**Ingleburn Resource Recovery Facility (SSD 8593)
Response to Submissions**

Attachment 1: Additional Information

**Ingleburn Resource Recovery Facility (SSD-8593)
Review of Response to Submissions Report**

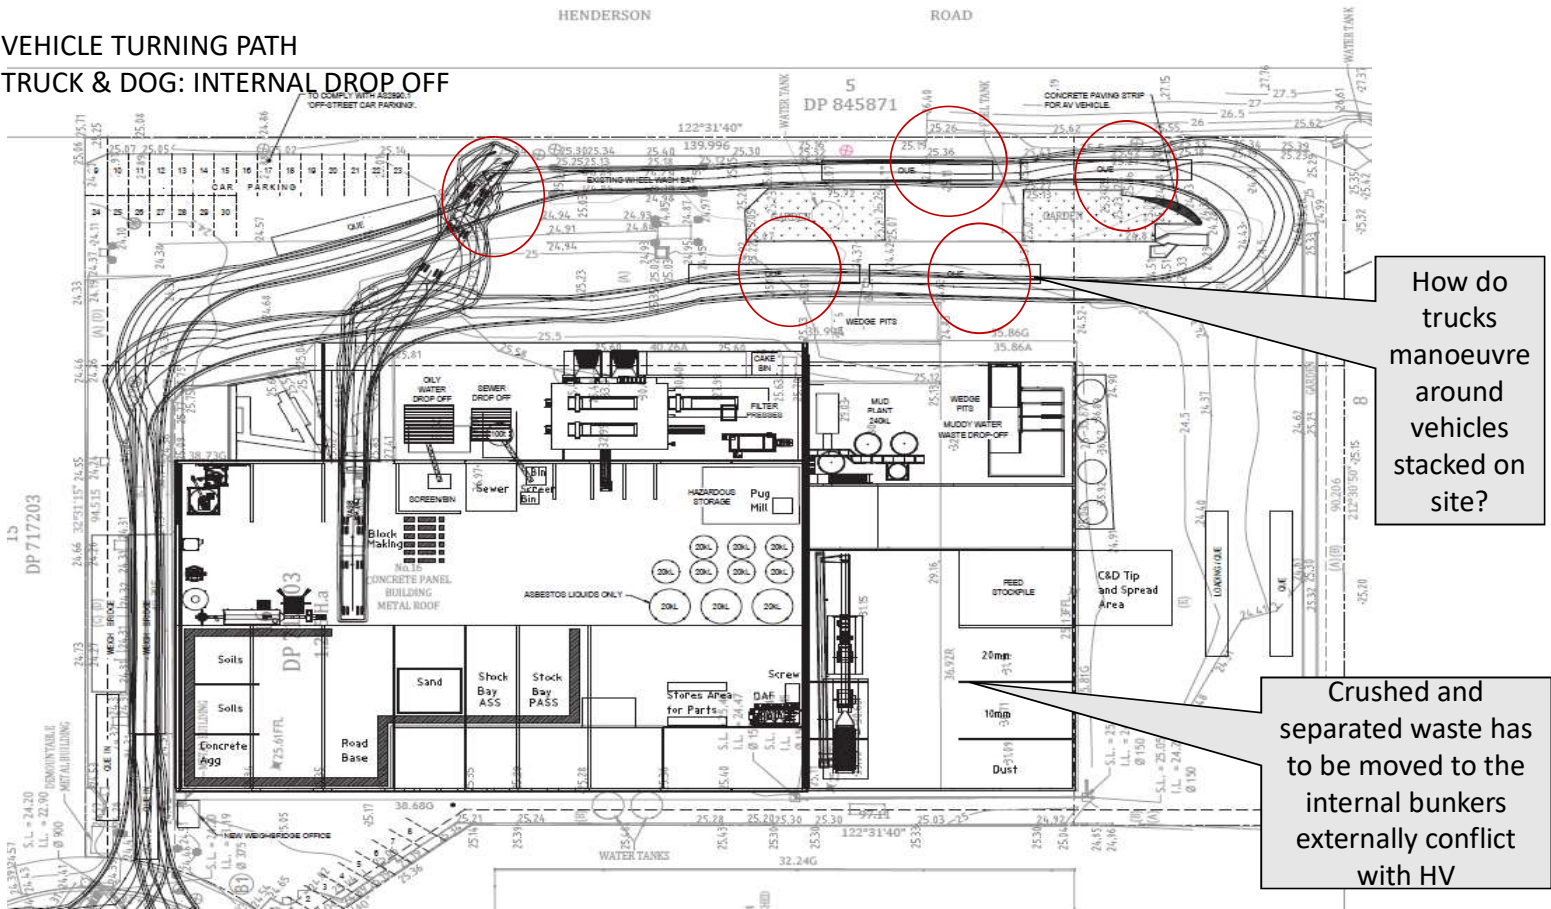
Internal bunker walls adjacent to the glass office wall

- Proposed noise wall not labelled
- Not all processes labelled roller doors not labelled
- Not all equipment labelled
- Liquid waste tanks not labelled

VEHICLE TURNING PATH
TRUCK & DOG: C & D TIP & SPREAD

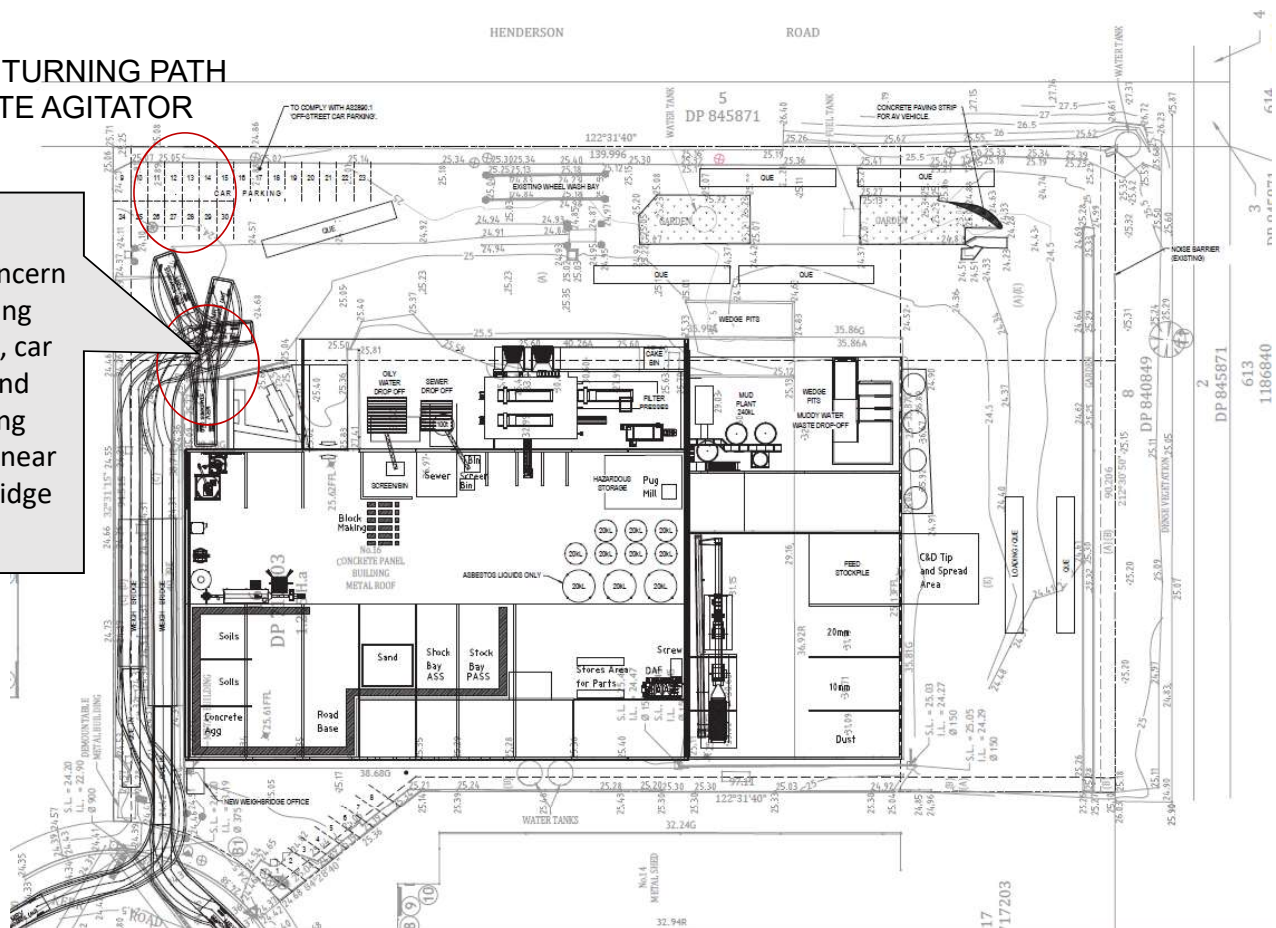
Safety concern reversing trucking, car park and queuing vehicles near weighbridge

How will two liquid waste vehicles manoeuvre in this space

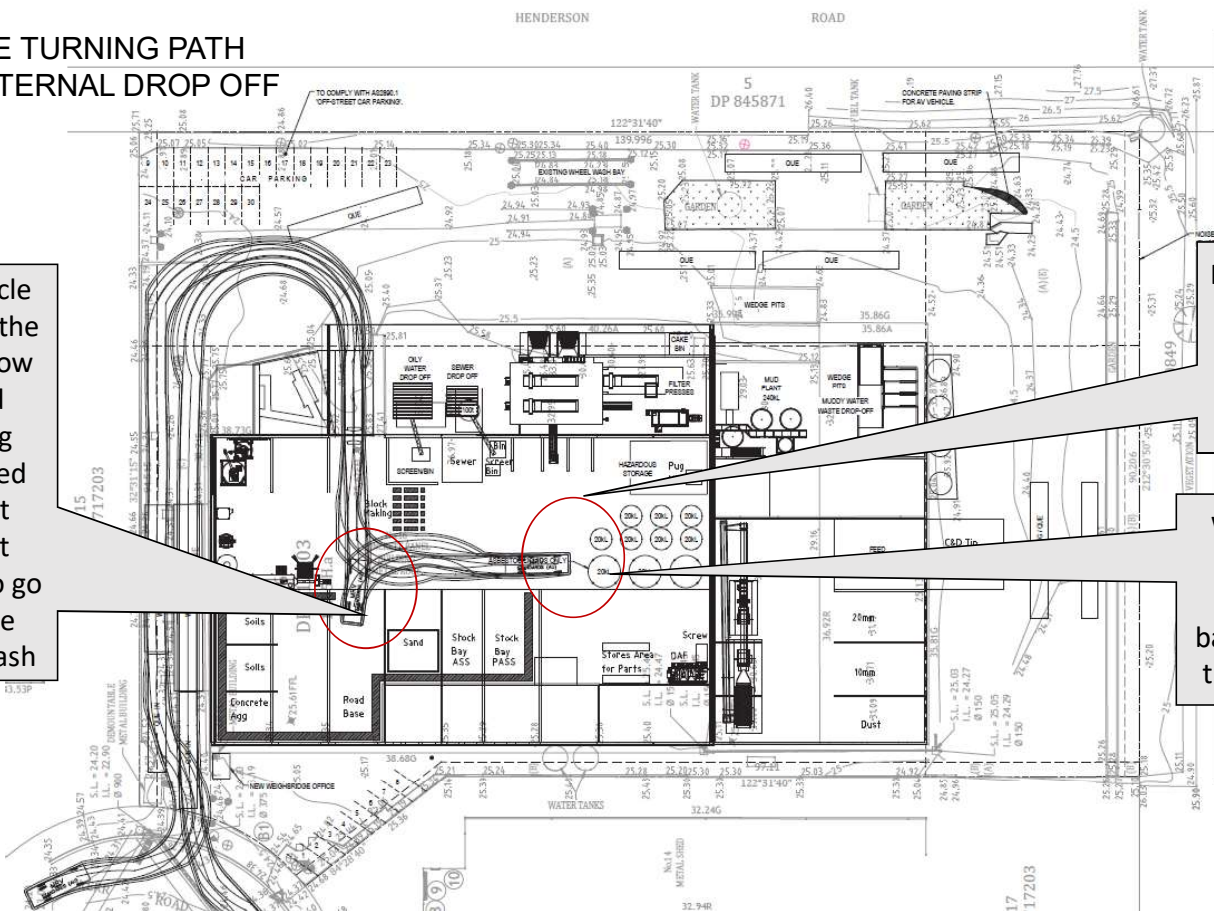
What's to prevent vehicles backing into the tanks ?
